NEW LIBRARY
LEARNING
RESOURCE
CENTER BUILDING

**LANDSCAPE SITE
LAYOUT PLAN**

SHEET NUMBER
A2.39.2

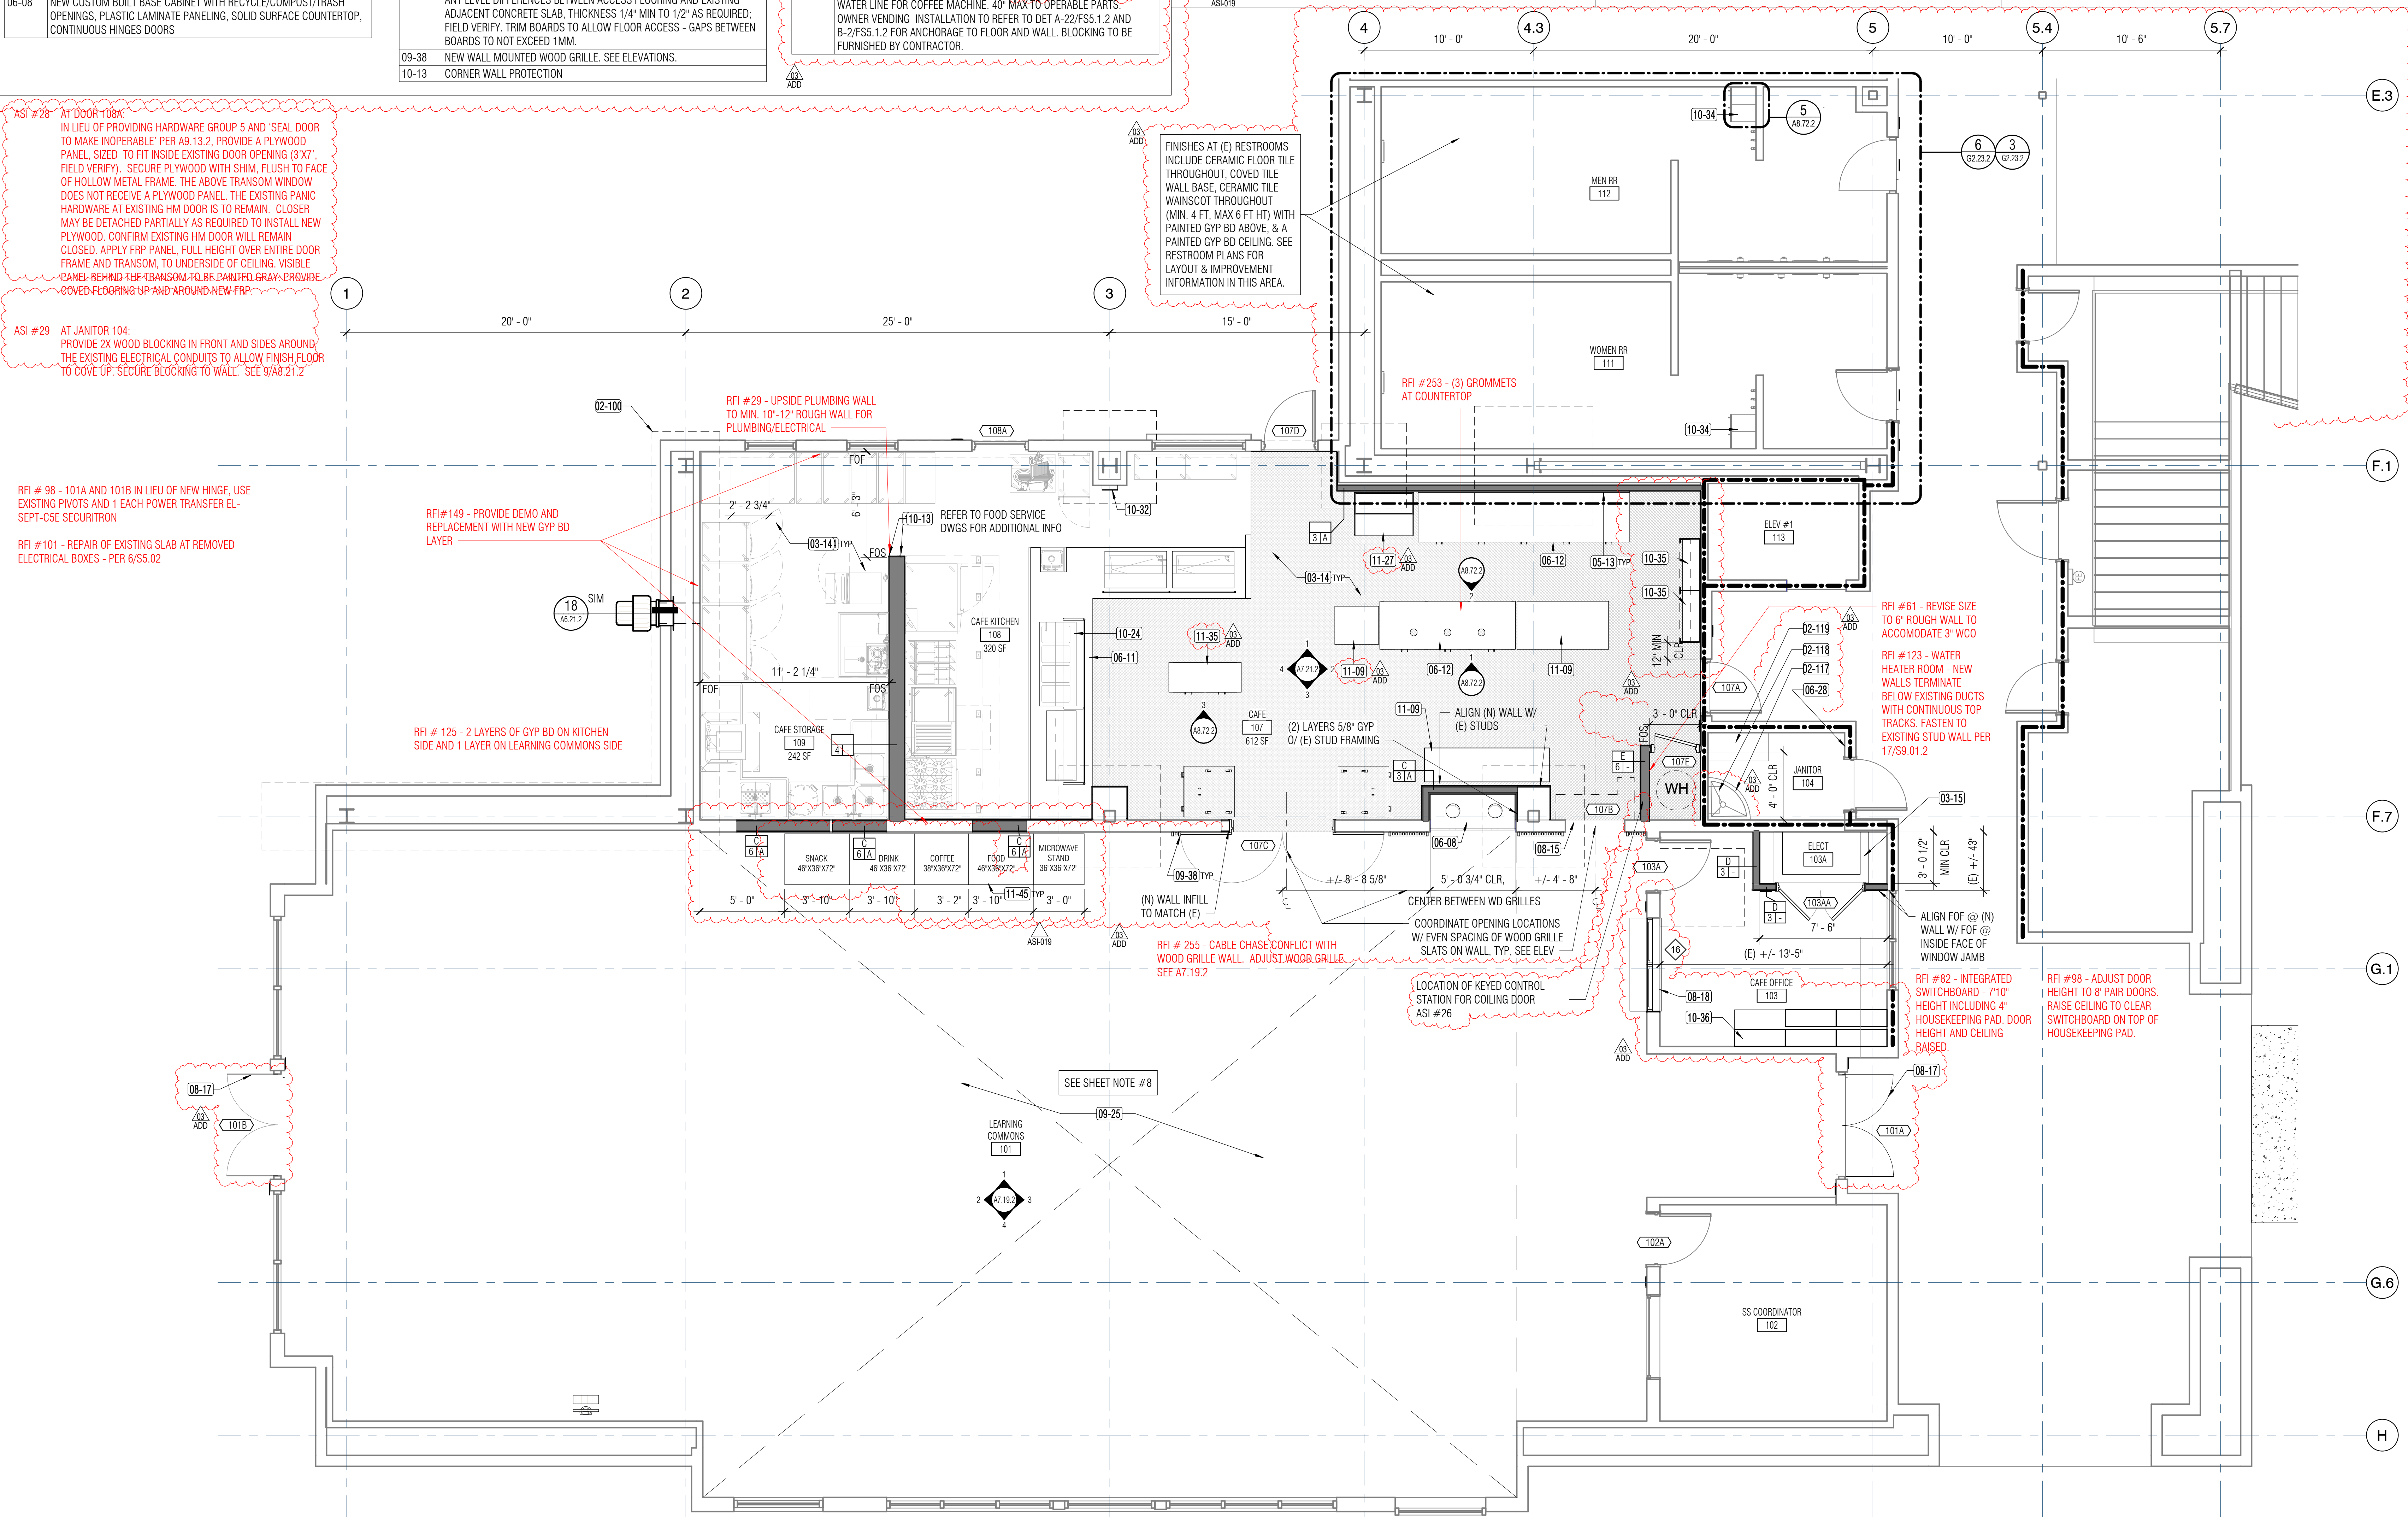
ASI #28 - AT DOOR 108A:
 IN LIEU OF PROVIDING HARDWARE GROUP 5 AND SEAL DOOR TO MAKE IMPERFERABLE PER A9.13.2, PROVIDE A PLYWOOD PANEL, SIZED TO FIT INSIDE EXISTING DOOR OPENING (3'X7'). FIELD VERIFY). SECURE PLYWOOD WITH SHIM, FLUSH TO FACE OF HOLLOW METAL FRAME. THE ABOVE TRANSOM WINDOW DOES NOT RECEIVE A PLYWOOD PANEL. THE EXISTING PANIC HARDWARE AT EXISTING HM DOOR IS TO REMAIN. CLOSER MAY BE DETACHED PARTIALLY AS REQUIRED TO INSTALL NEW PLYWOOD. CONFIRM EXISTING HM DOOR WILL REMAIN CLOSED. APPLY FRP PANEL, FULL HEIGHT OVER ENTIRE DOOR FRAME AND TRANSOM, TO UNDERSIDE OF CEILING. VISIBLE PANEL BEHIND THE TRANSOM TO BE PAINTED GRAY. PROVIDE COVERED FLOORING UP AND AROUND NEW FRP.

ASI #29 AT JANITOR 104:
 PROVIDE 2X WOOD BLOCKING IN FRONT AND SIDES AROUND THE EXISTING ELECTRICAL CONDUITS TO ALLOW FINISH FLOOR TO COVER UP. SECURE BLOCKING TO WALL. SEE 9/48.21.2

RFI #98 - 101A AND 101B IN LIEU OF NEW HINGE, USE EXISTING PIVOTS AND 1 EACH POWER TRANSFER EL-SEPT-C5E SECURITRON

RFI #101 - REPAIR OF EXISTING SLAB AT REMOVED ELECTRICAL BOXES - PER 6/55.02

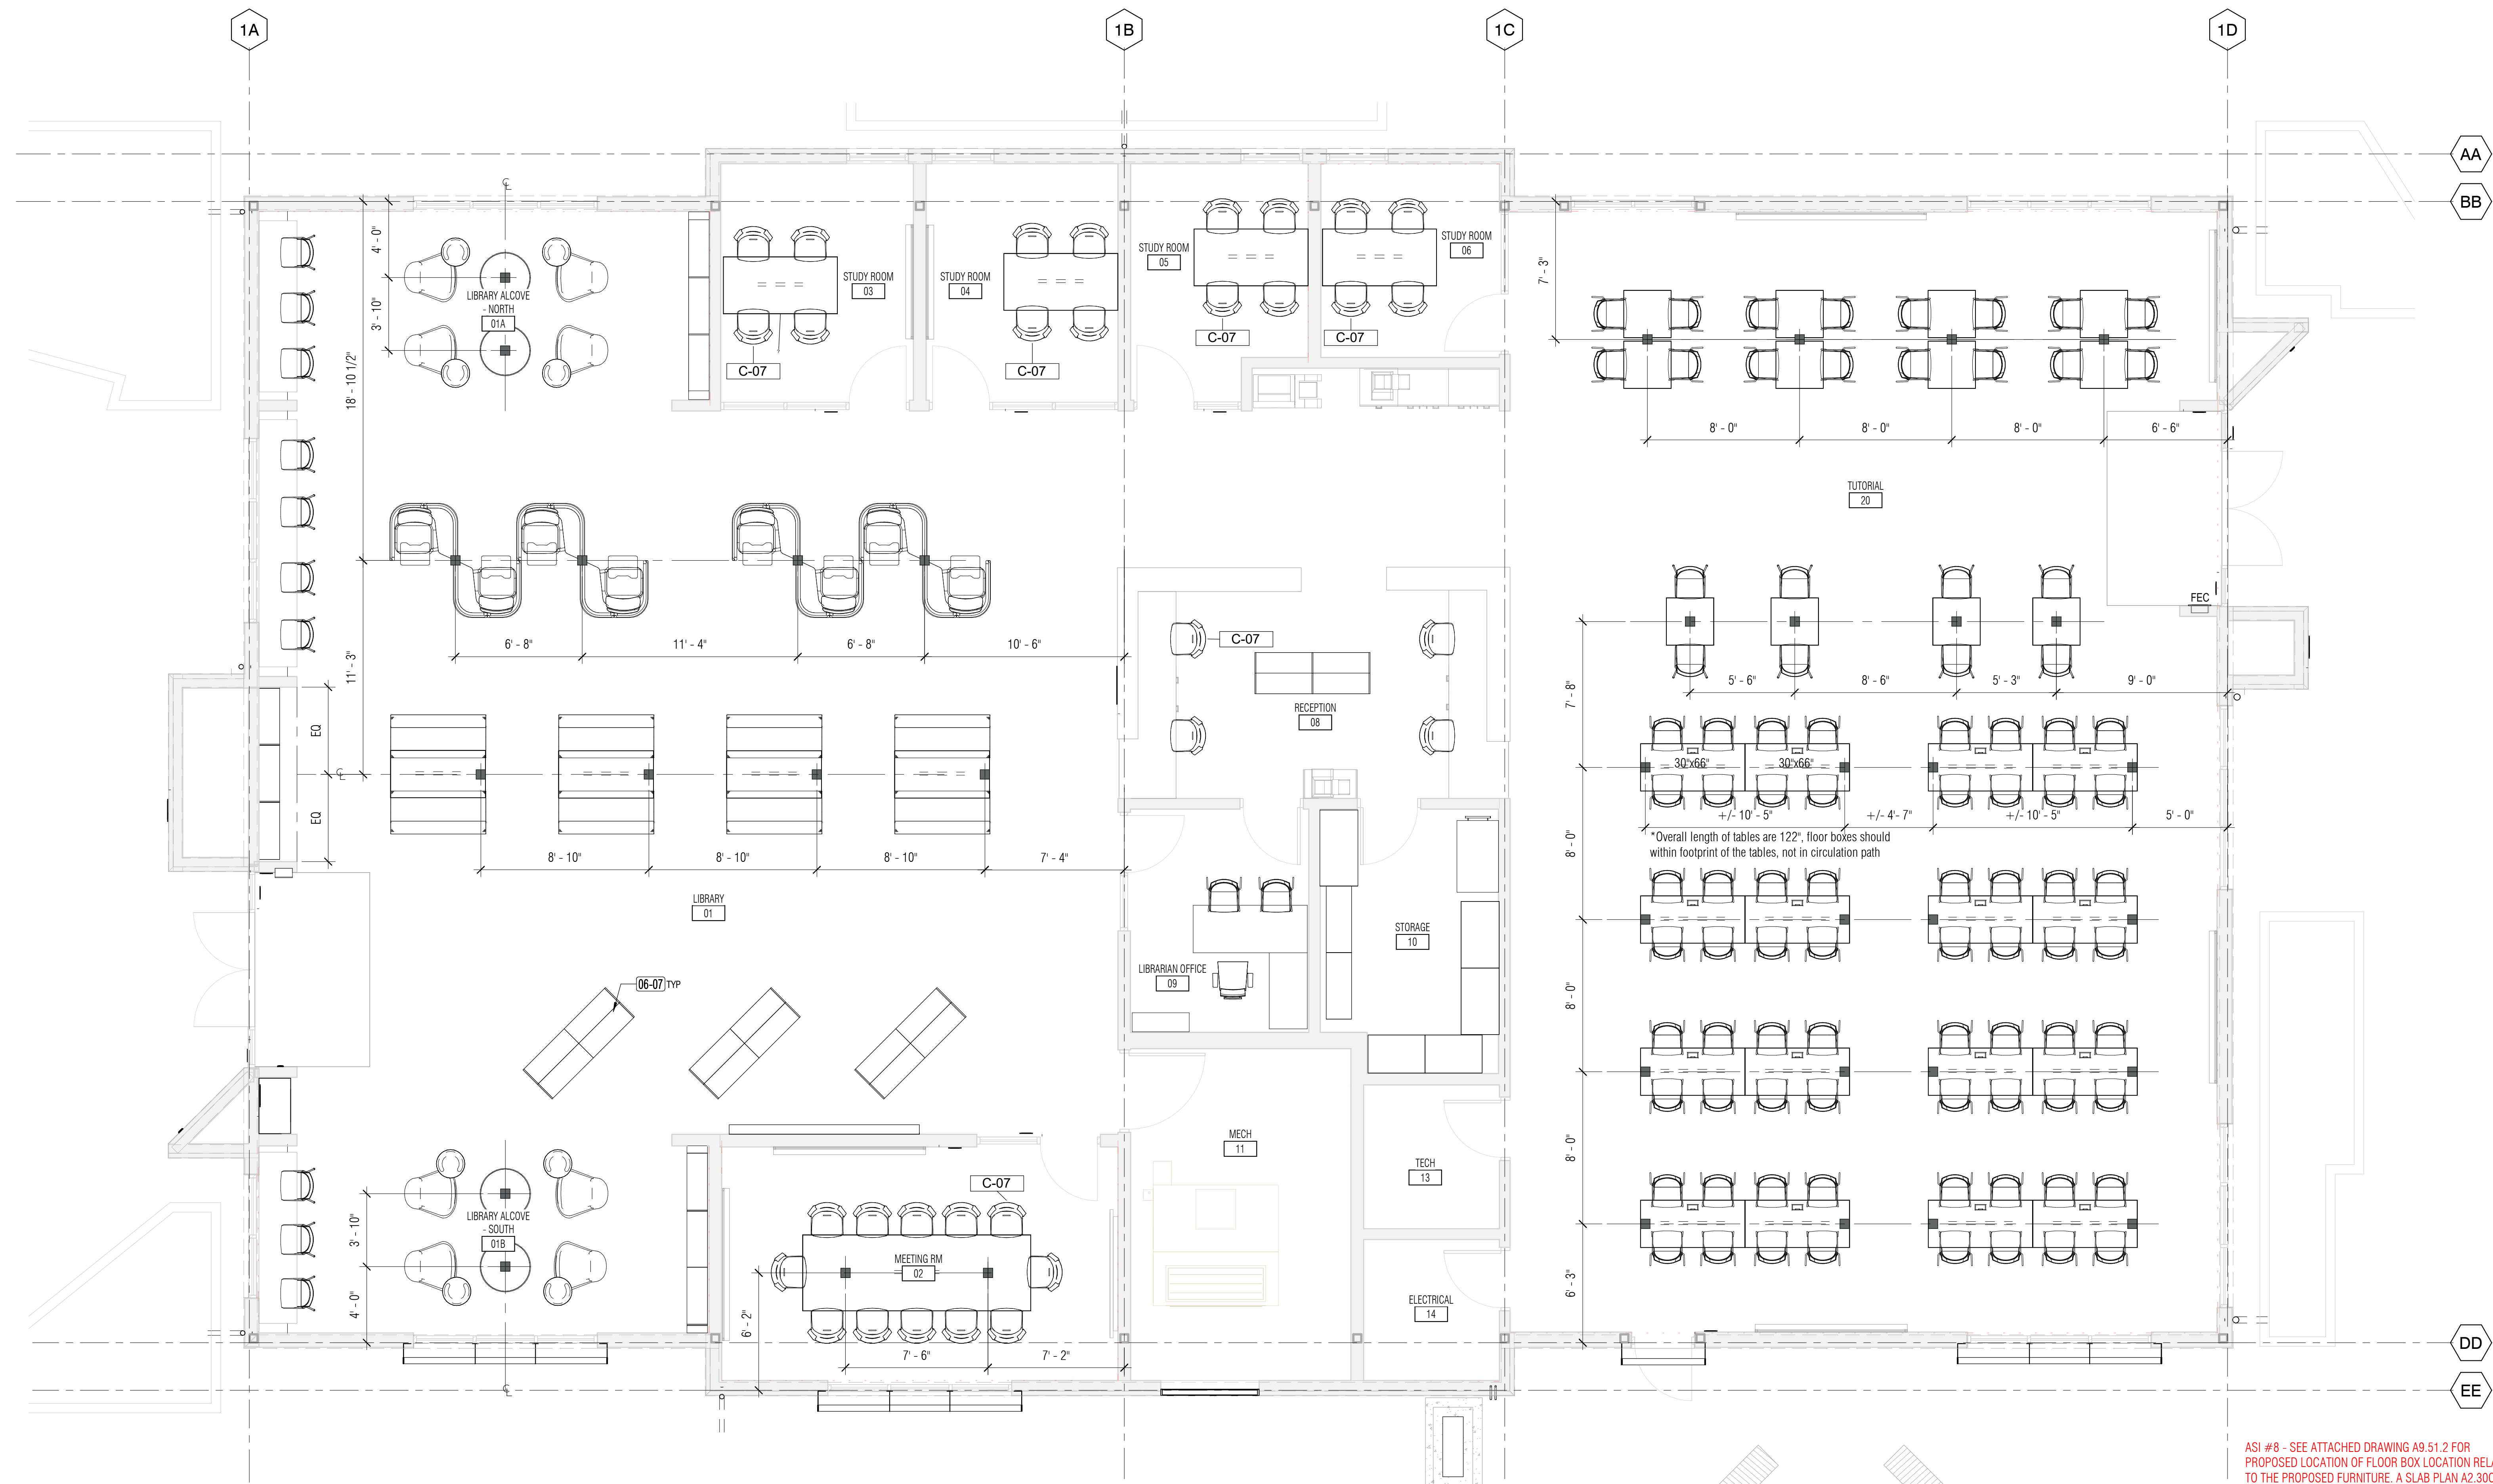
ASI #8 - SEE ATTACHED DRAWING A9.51.2 FOR PROPOSED LOCATION OF FLOOR BOX LOCATION RELATIVE TO THE PROPOSED FURNITURE. A SLAB PLAN A2.30C IS ALSO ATTACHED WITH LOCATION OF FLOOR BOXES.

E2.49.2

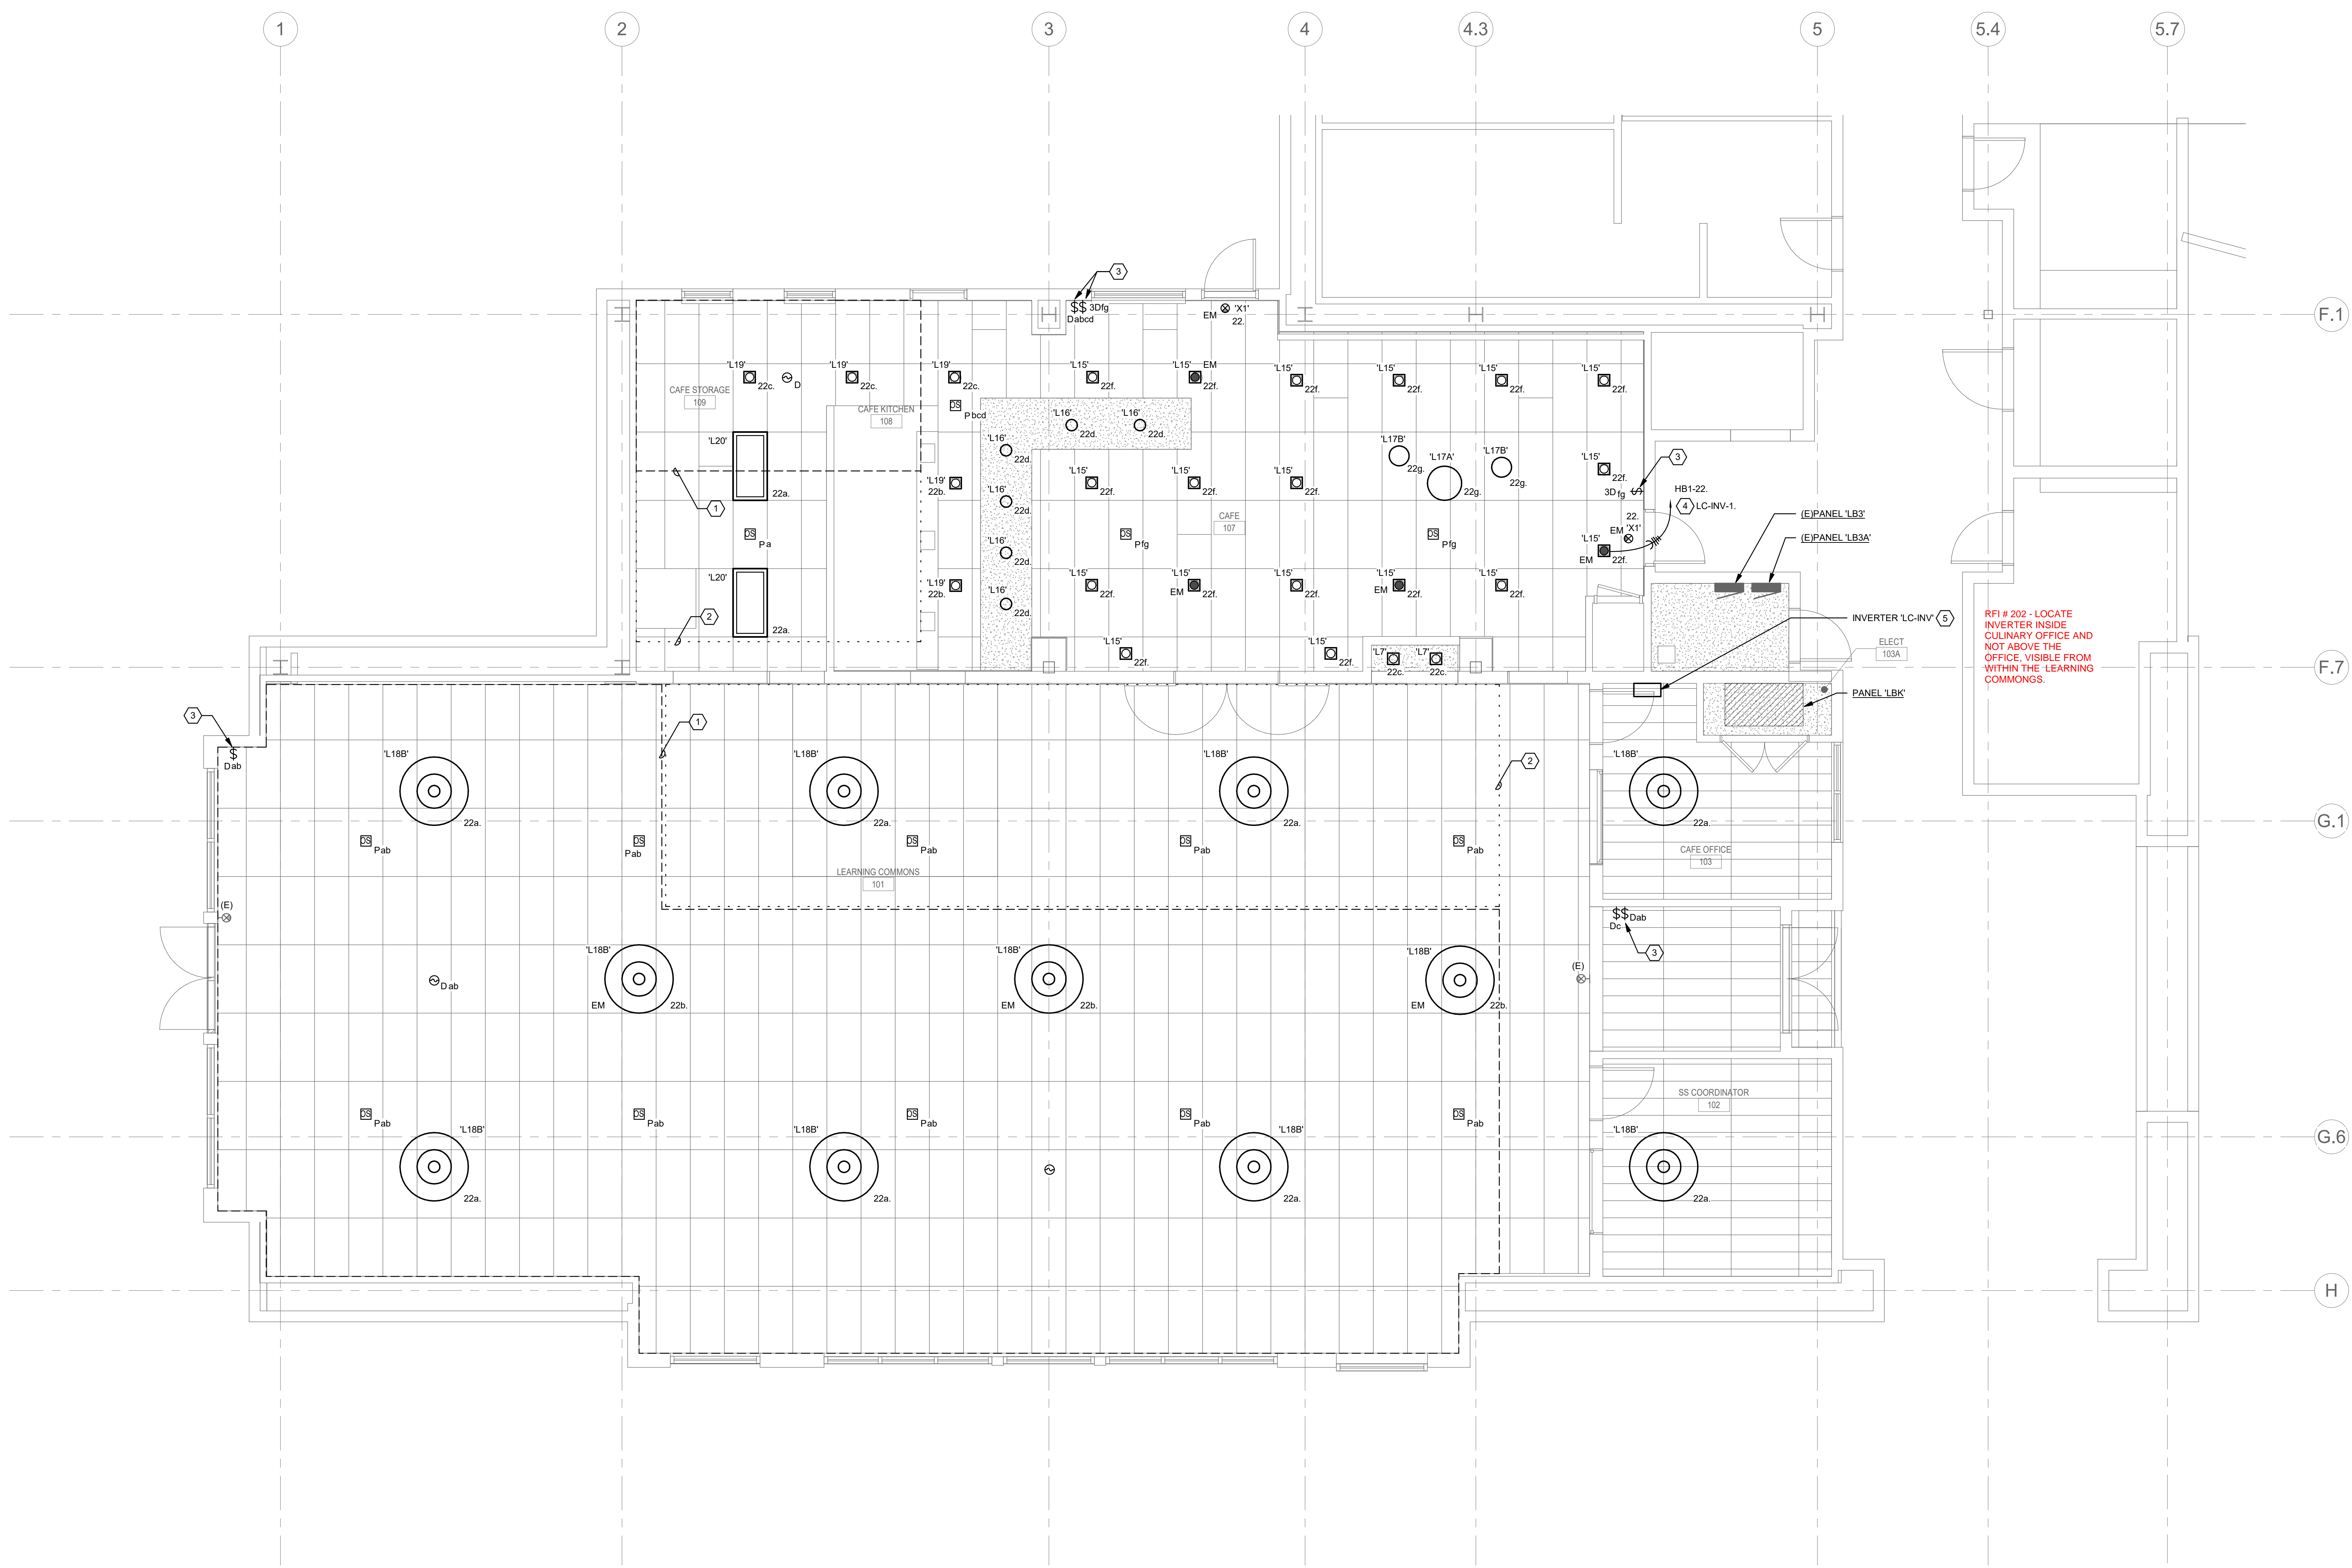
RFI # 202 - LOCATE
INVERTER INSIDE
CULINARY OFFICE AND
NOT ABOVE THE
OFFICE, VISIBLE FROM
WITHIN THE LEARNING
COMMONS.
